EXHIBIT LIST FOR SUB 2021-001/EA 2021-005
Preliminary Plat of Harvest Ridge

STAFF REPORT TO THE BENTON COUNTY
PLANNING COMMISSION

FILE NO: SUB 2021-001
Preliminary Plat of Harvest Ridge

PRELIMINARY PLAT OF HARVEST RIDGE

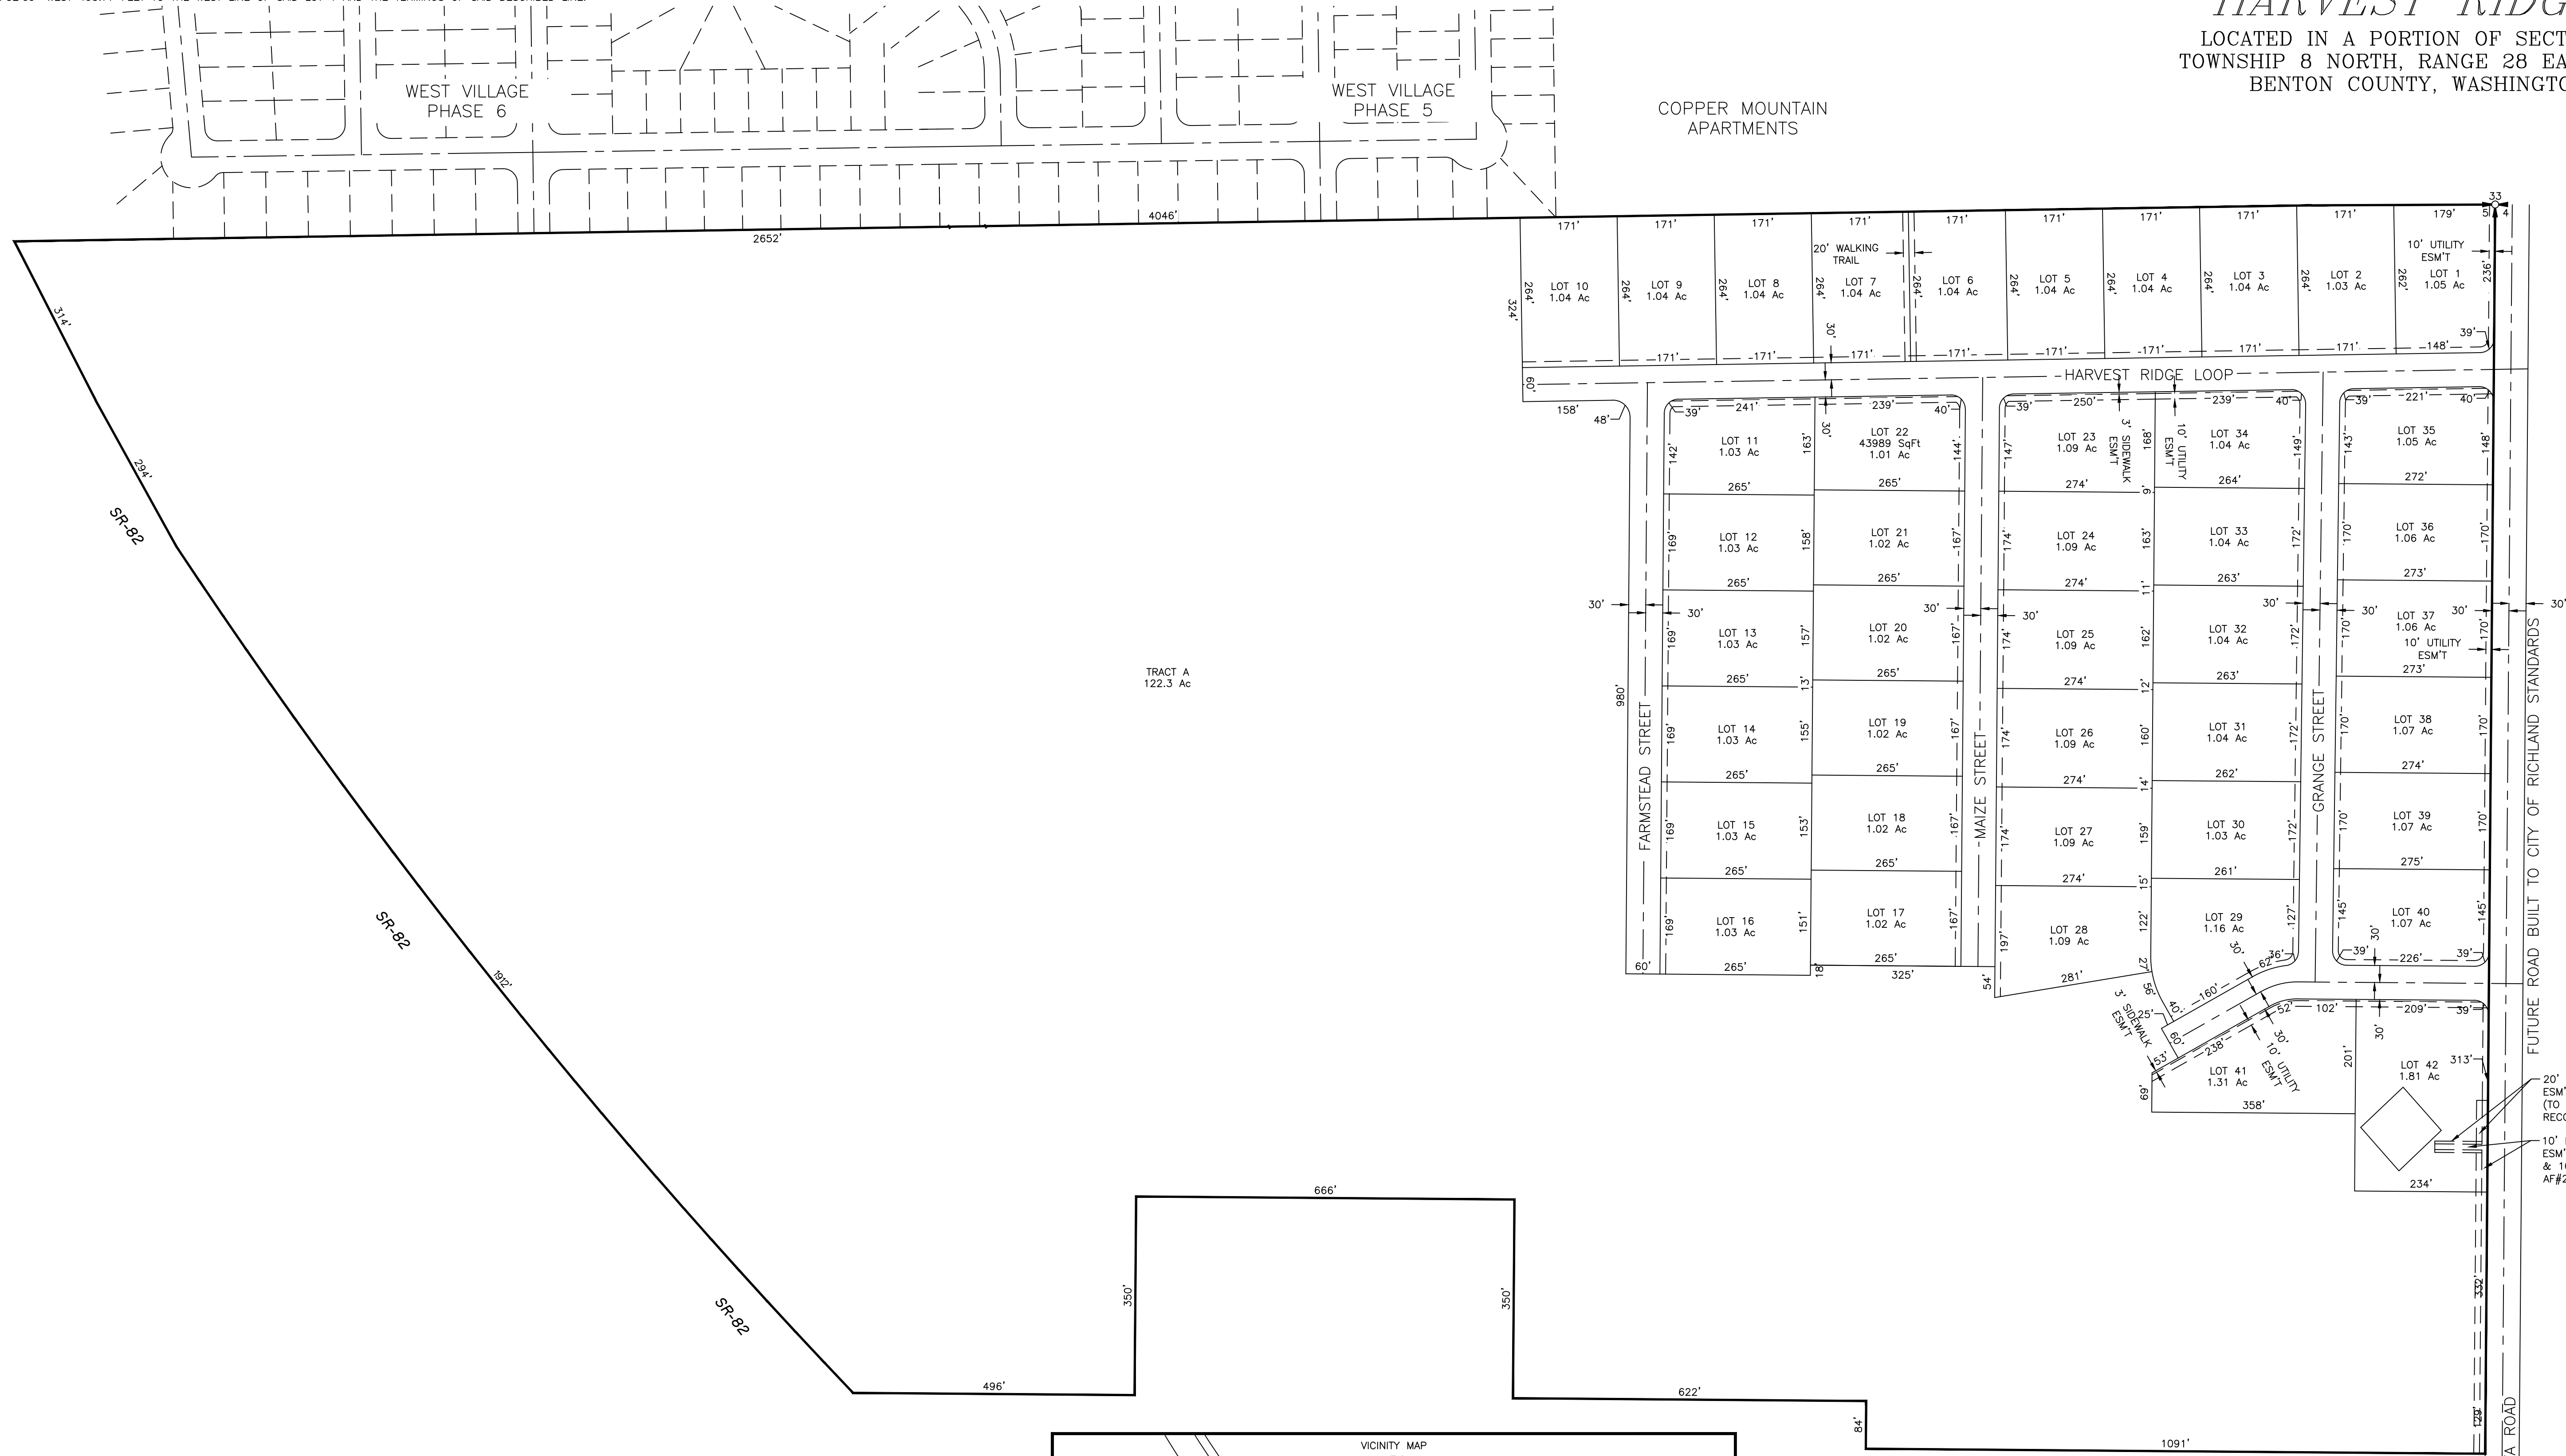
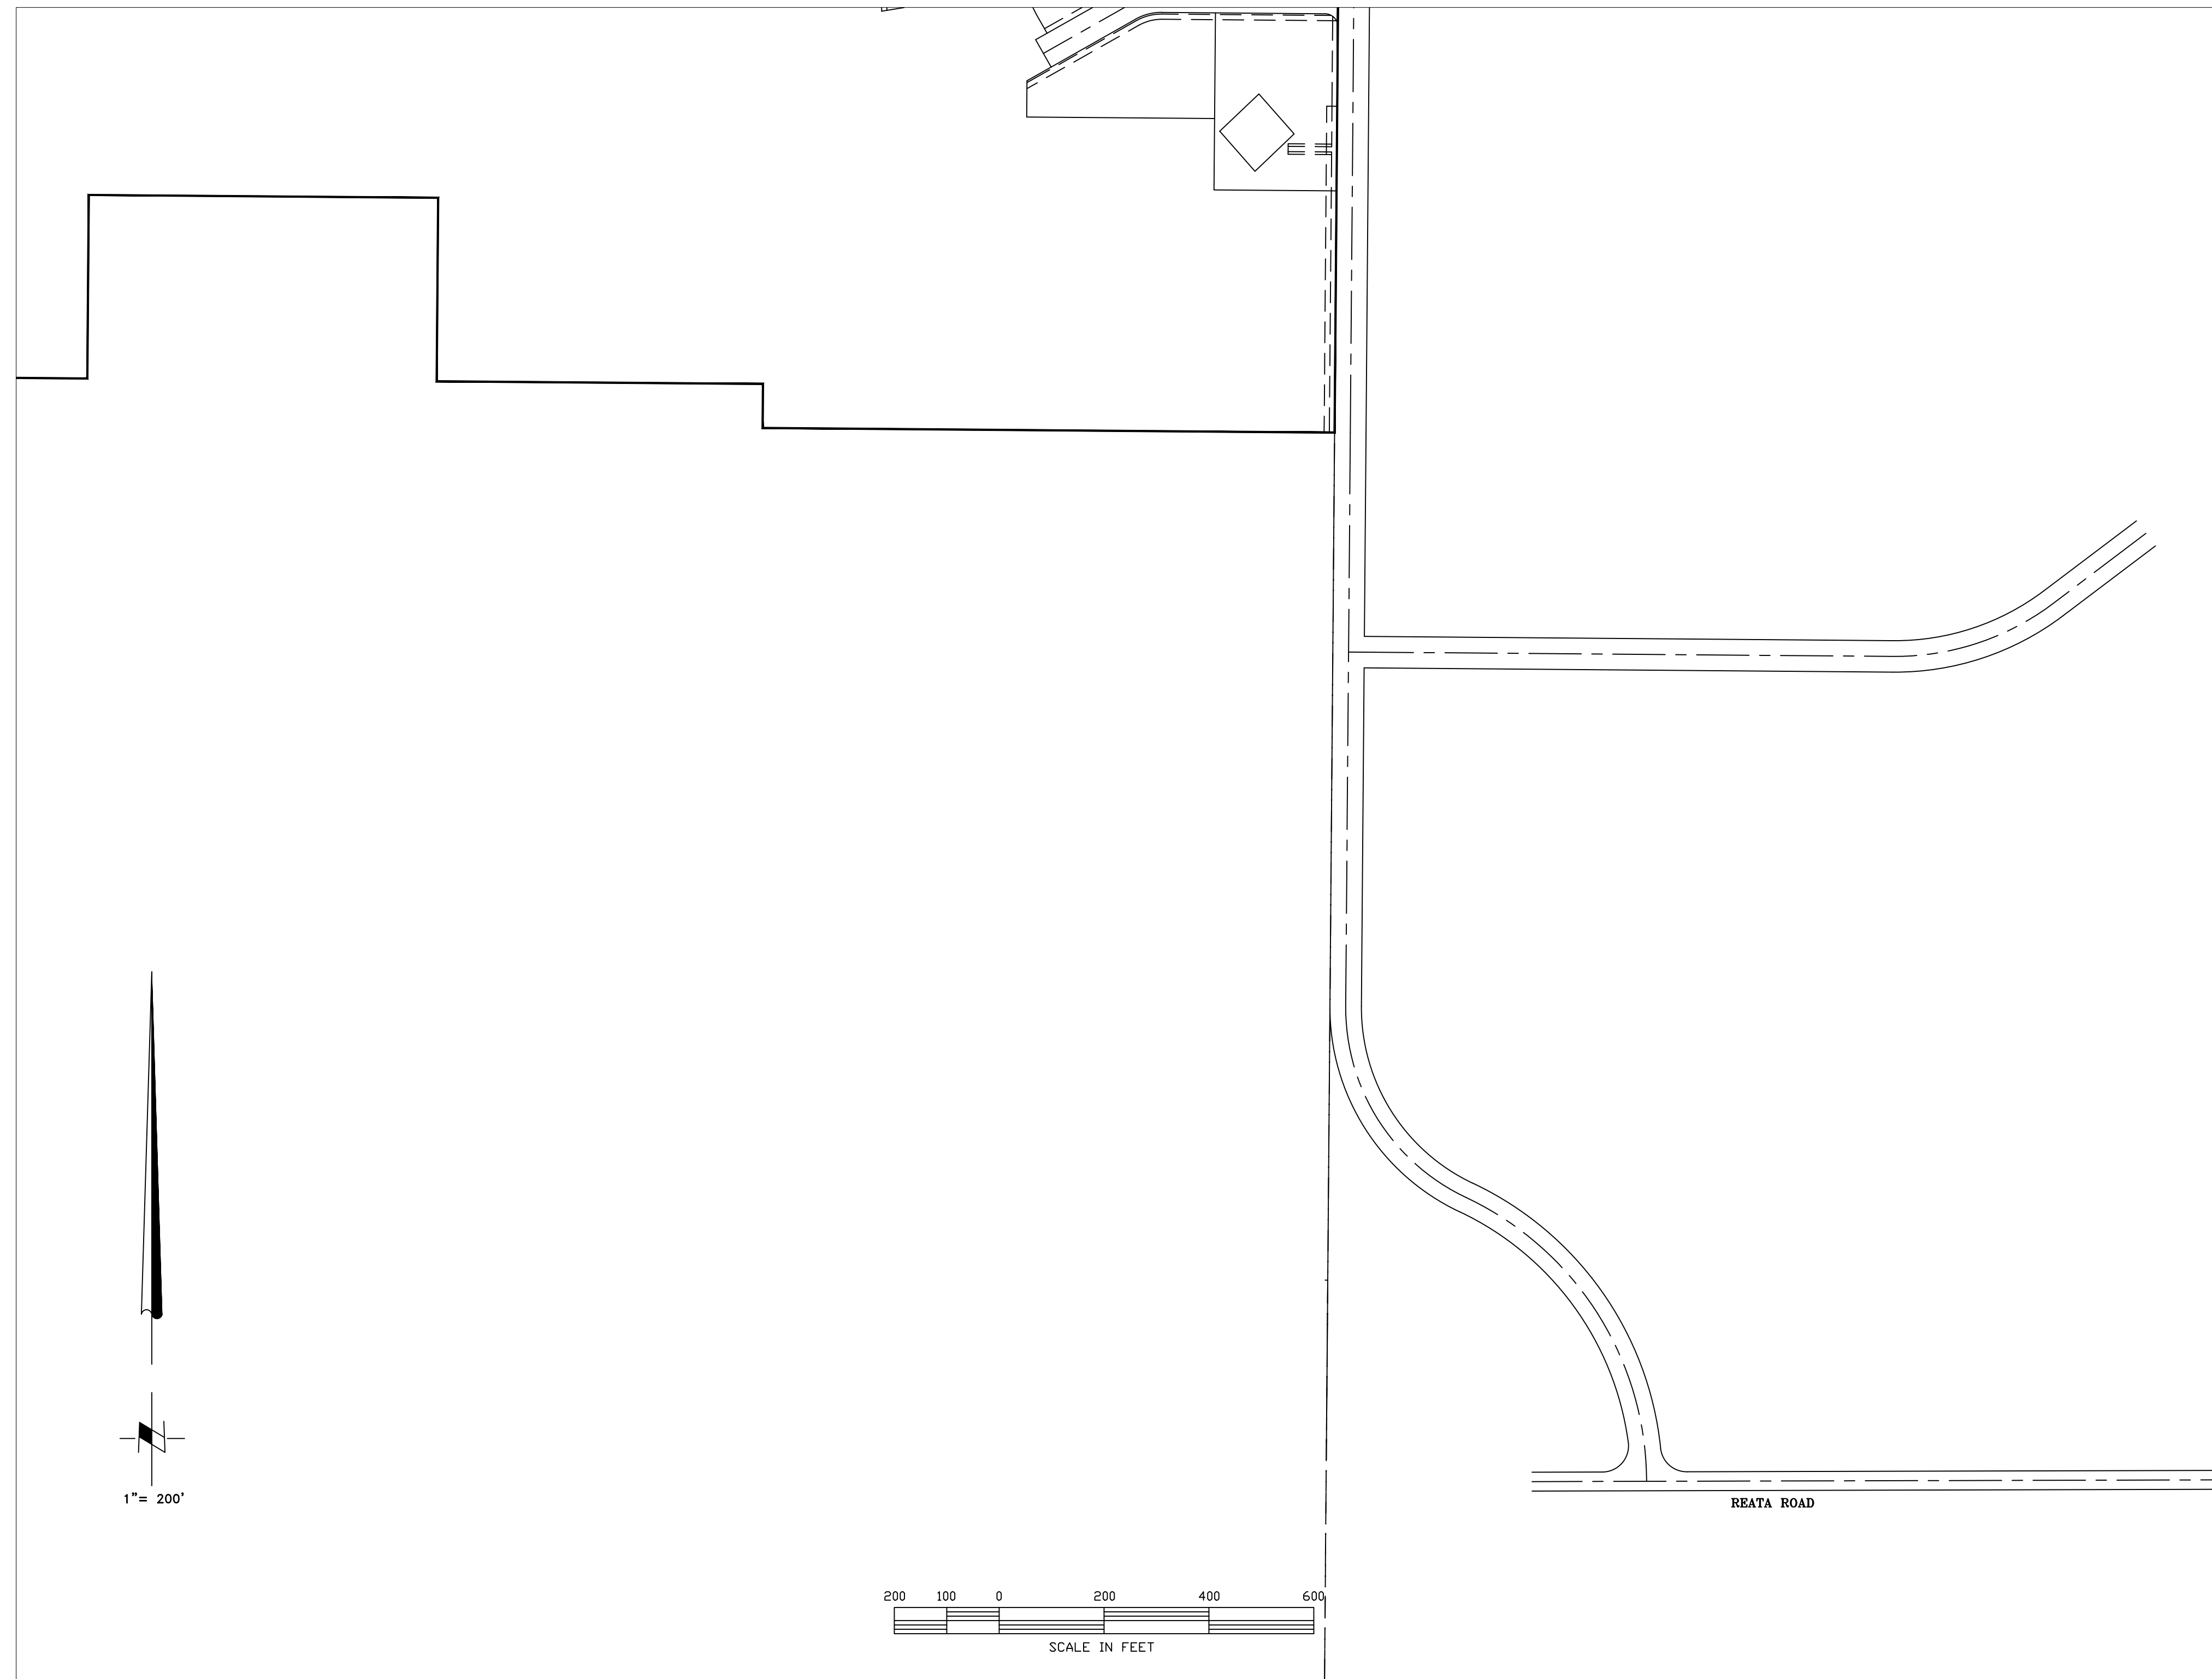
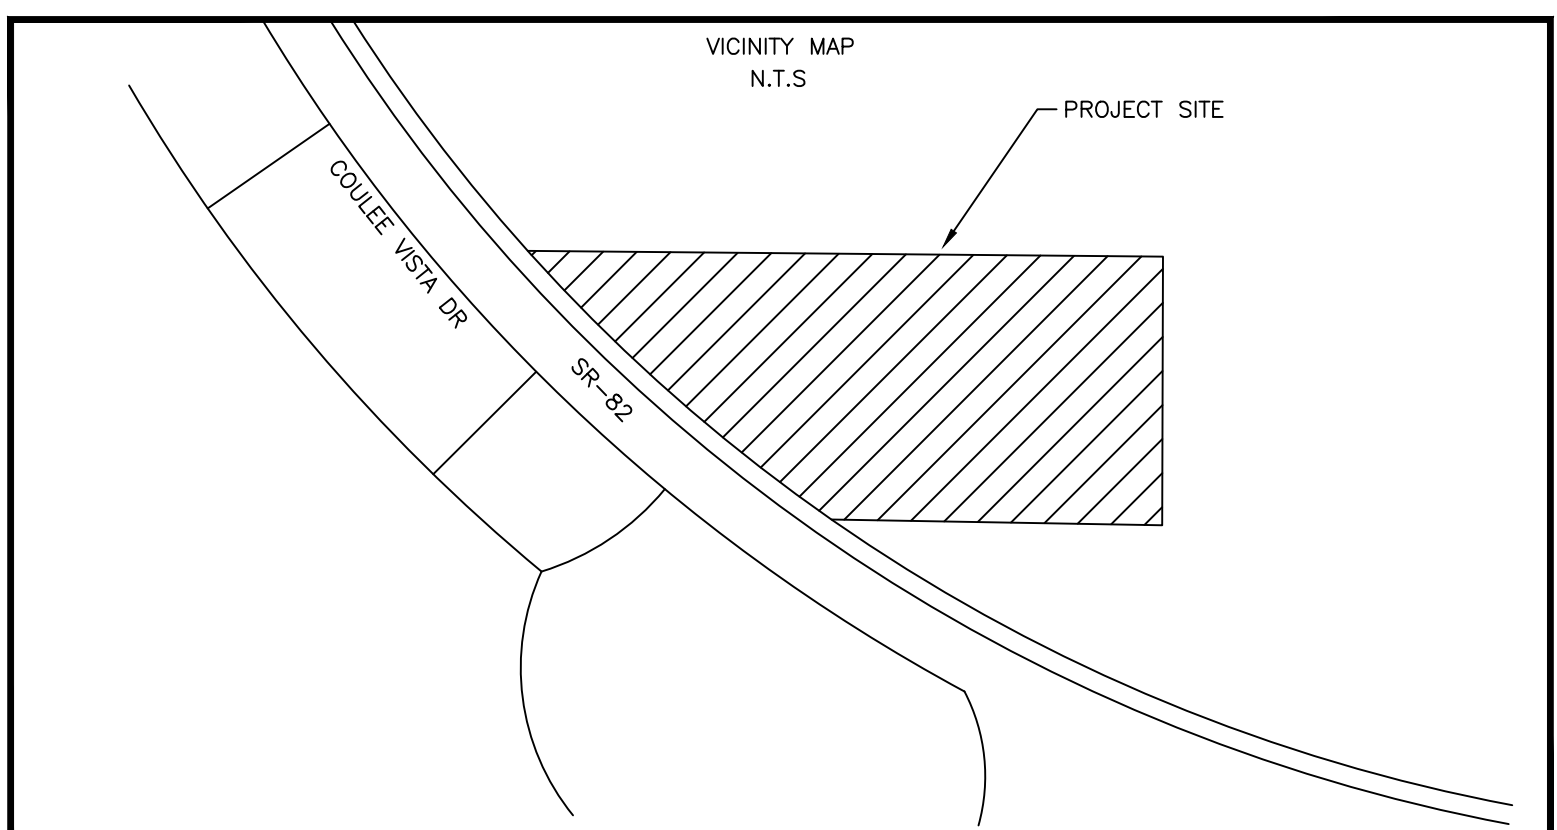
1. The proposed subdivision (PCM 1.6, application and PCM 1.7, preliminary plat map) conforms to the Benton County Comprehensive Plan, any applicable zoning requirements and other applicable land use controls;

- g. Show the location, name, right-of-way widths, and type of surfacing of all streets located within and adjacent to the land to be subdivided on the plat map.

22. That the preliminary plat is modified in all necessary respects so that the final plat will reflect the requirements of approval. If the final plat will be in conflict with any of the conditions of approval as adopted by the Planning Commission as a result of the modifications, then the final plat must be reviewed by the Planning Commission at a public meeting for approval prior to sending the final plat to the Board of County Commissioners.
